RE: United Power Stonehouse Substation Conditional Use Permit – RCU2025-00008 Submittal 3

Ulteig on behalf of United Power, Inc. respectfully delivers this third submittal for the Stonehouse Substation Conditional Use Permit application RCU2025-00008.

Adams County Comments and United Power/Ulteig Responses

1000 ft

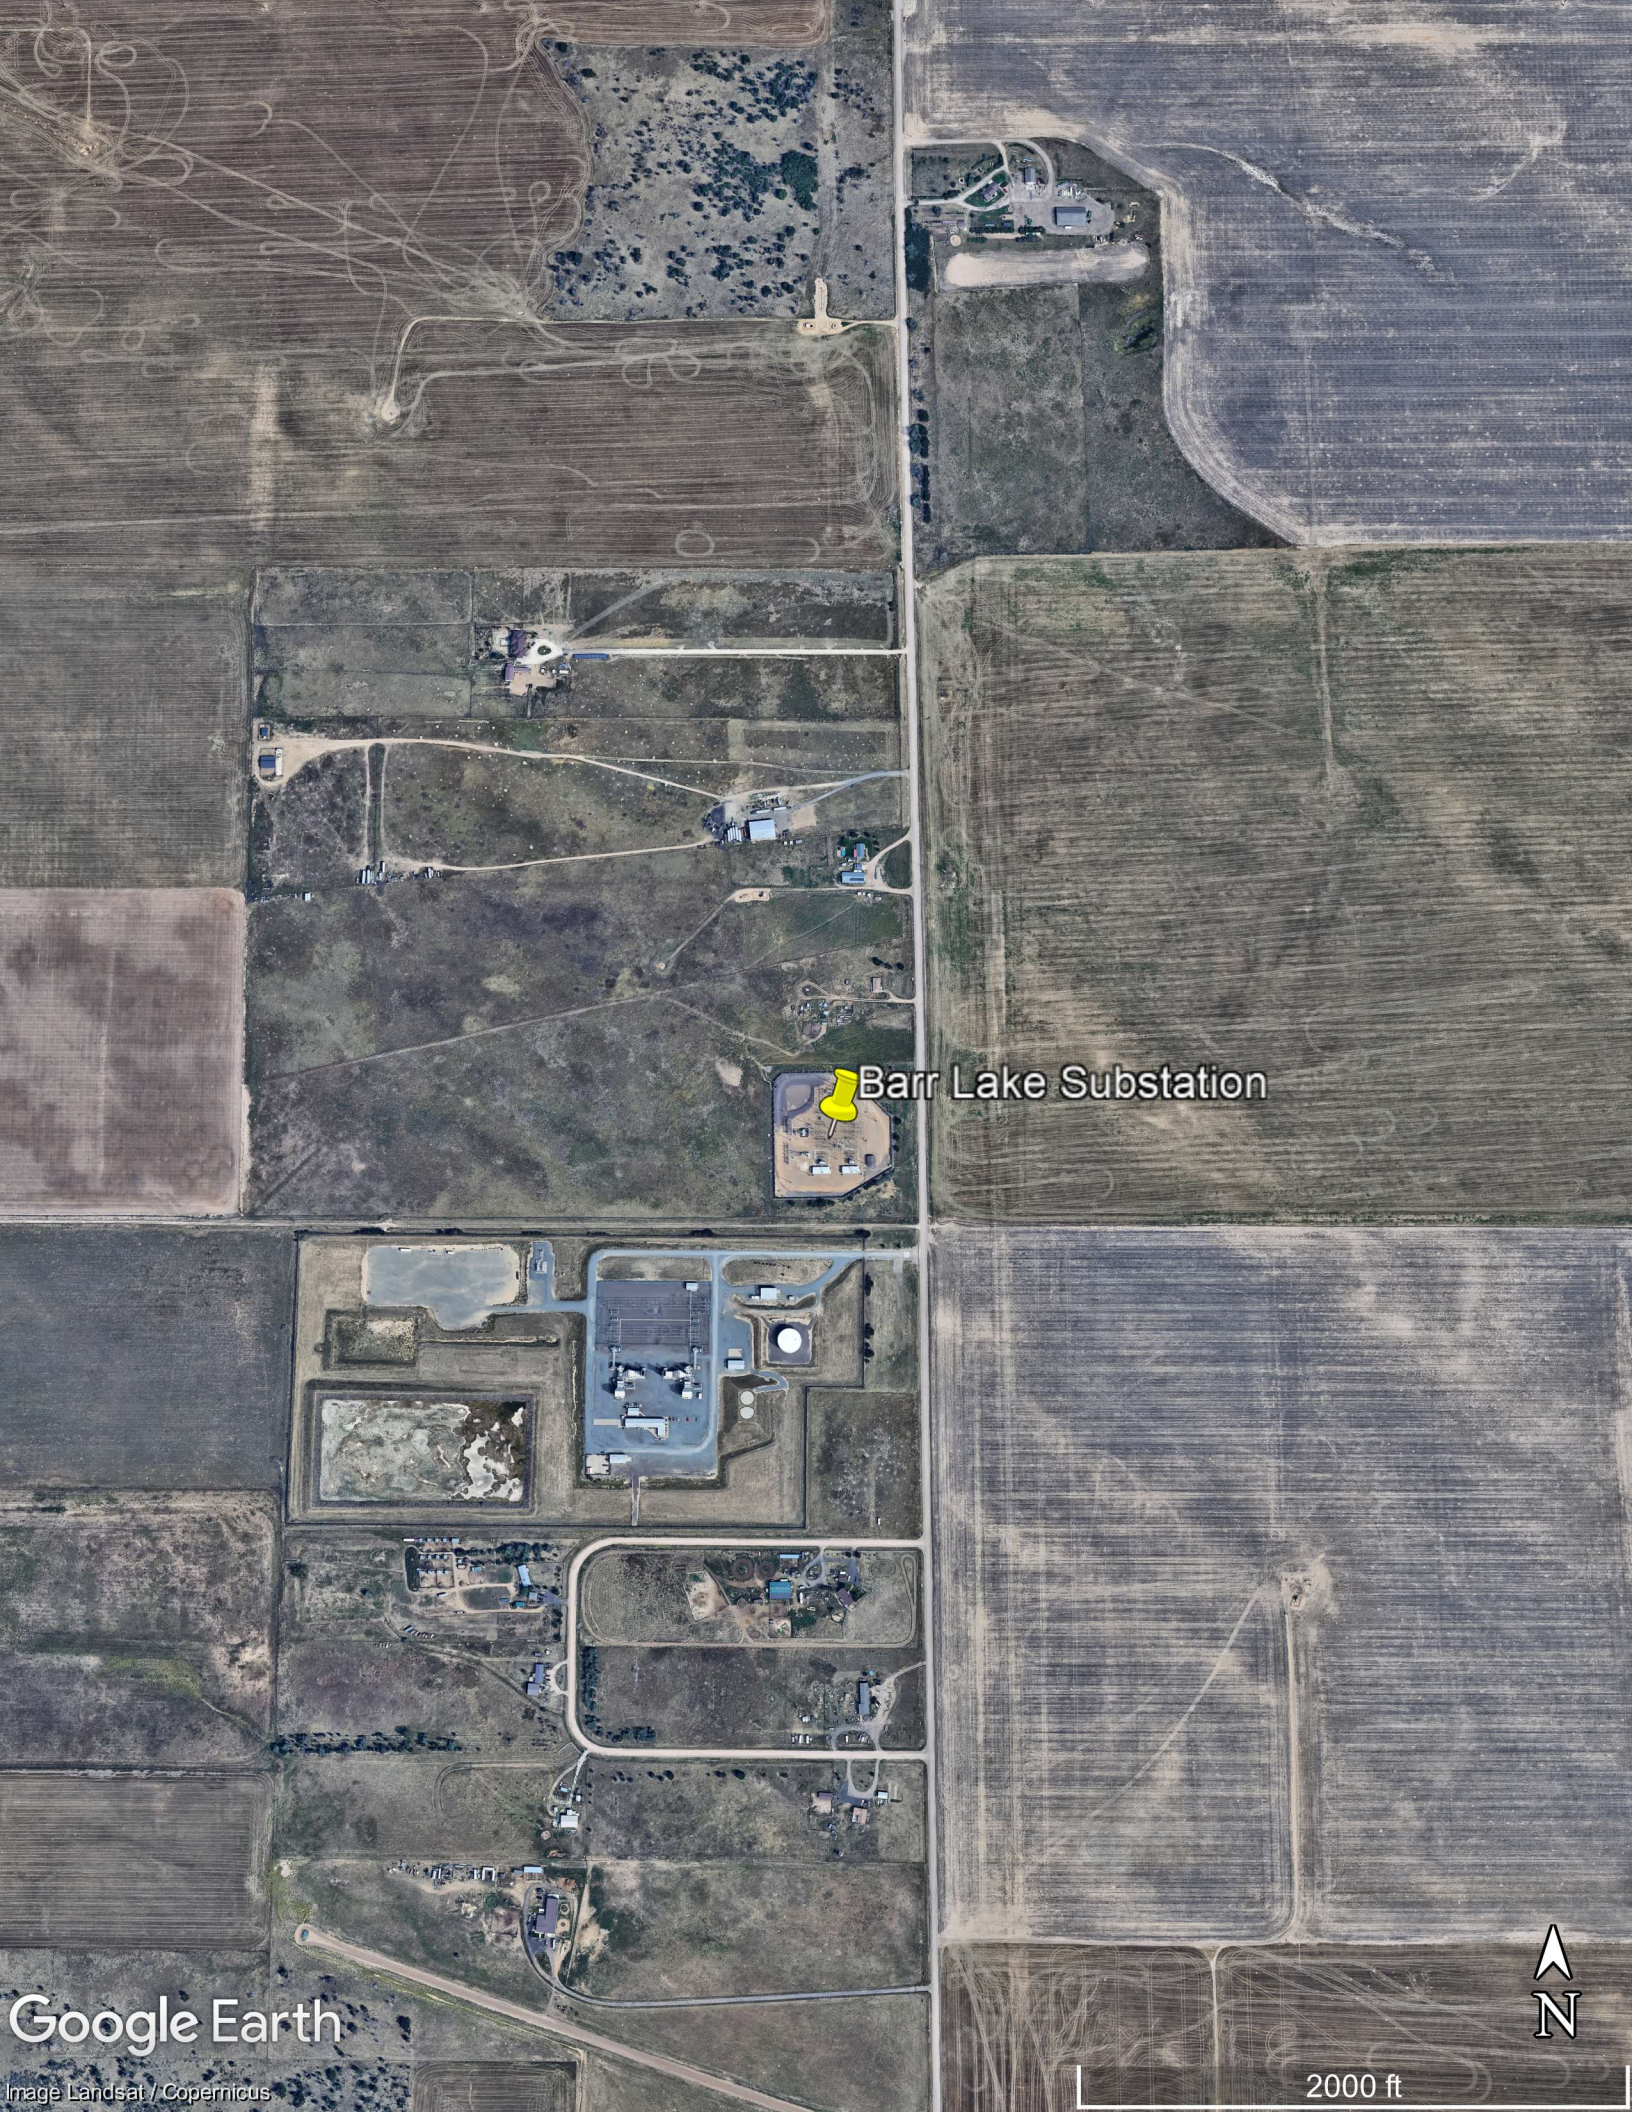
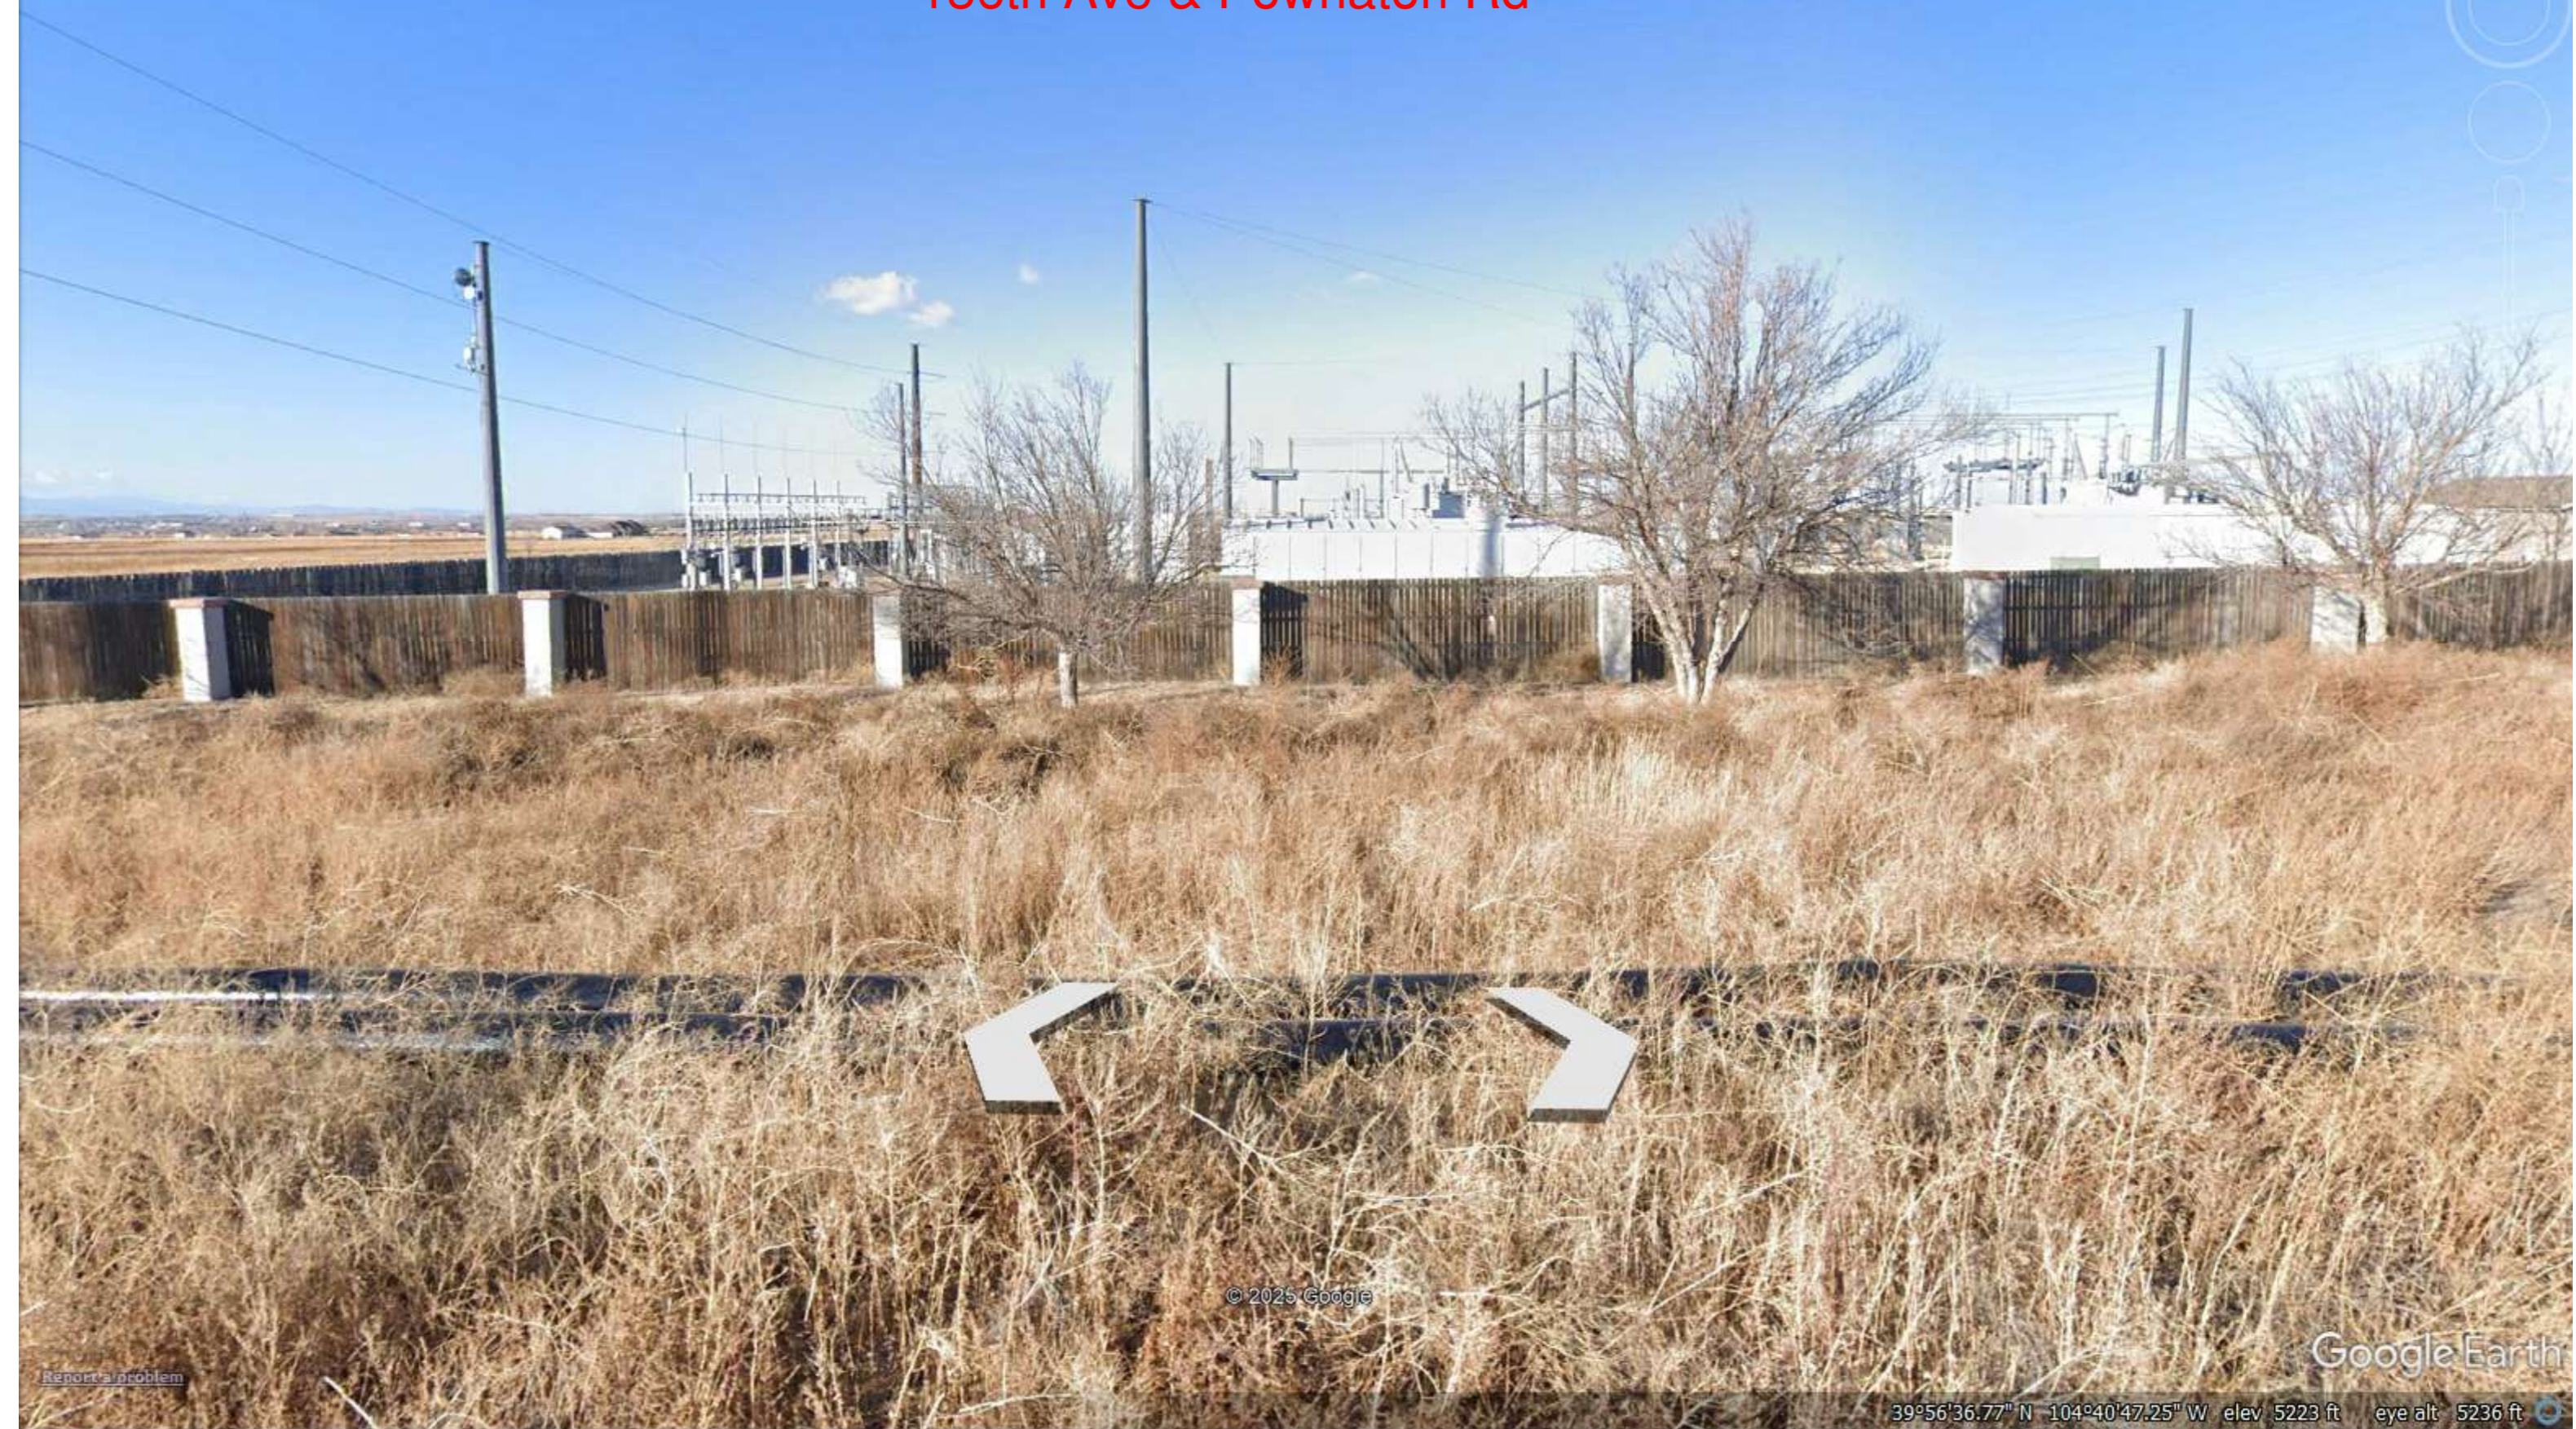
We would like for you to explore more opportunities for landscaping. The site is located within a portion of the county where landscaping relief is more difficult to justify. Have you explored native plants and xeriscaping?

For reference, we are including a series of maps/photos that show United Power's existing substations in the surrounding area and the lack of landscaping at each.

United Power has gathered maps and photos from 4 of their existing substation sites, within the vicinity of the proposed Stonehouse Substation, to demonstrate the on-site landscaping in order to help justify the absence of landscaping at the proposed Stonehouse Substation. This is a supplement to the response that was provided to address the landscaping comments from County staff.

STONEHOUSE SUBSTATION
SITE PLAN

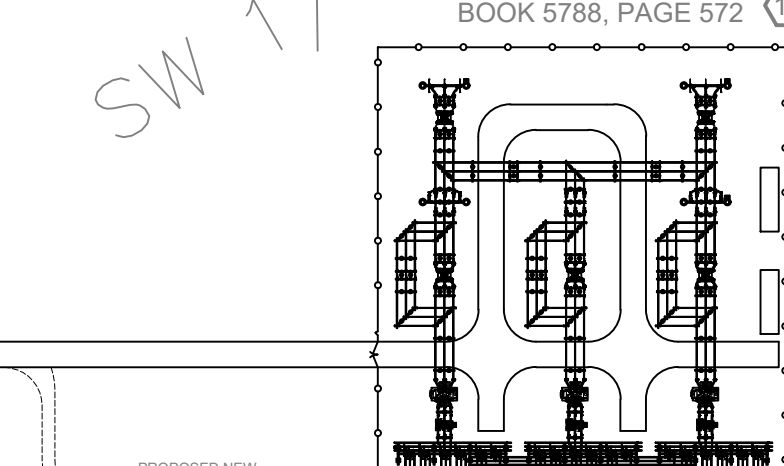
ROW1: Revise the site plan to show the record boundary with dimensions, any existing easements, location of existing roads for access purposes, existing structures with tie dimensions to the record boundary.

ROW2: On the site plan, show the recorded information of the document providing right-of-way access to the site. Additionally, show all survey section corner information to help determine the location of the site boundary

Response: Record boundary with dimensions, existing easements, and roads are shown on attached site plan. The site is laid out on top of the ALTA survey that was prepared for the site.

Response: Recording information could not be found for the existing access off of Gun Club Rd. to the oil and gas well. United Power submitted a request to the County for permission to access Gun Club Rd. for the substation site, which was approved provided that the plans clearly show the access point merging with the existing oil and gas pad site entrance and the substation site design must not include access onto E 132nd Avenue. The attached site plan shows the Gun Club Rd. access point, an offshoot to access the oil and gas site, so both sites can be accessed off Gun Club Rd. from the same spot, and the removal of the E. 132nd Avenue access point. The survey section corner information is included on the site plan. An additional drawing is included that shows the site plan laid on top of the ALTA survey that was prepared for the site, which also includes the survey section corner information. This drawing also depicts the correct property boundaries that follow the interior limits of the surrounding road ROW, which has been coordinated and confirmed with Ian Cortez.

1. Record boundary with dimensions, existing easements, location of existing roads for access purposes, existing structures with tie dimensions to the record boundary were added to the Site Plan.
2. The recorded information of the document providing right-of-way access to the site was added to the Site Plan and ALTA Overview Plan.
3. All survey section corner information was added to the Site Plan to help determine the location of the site boundary.
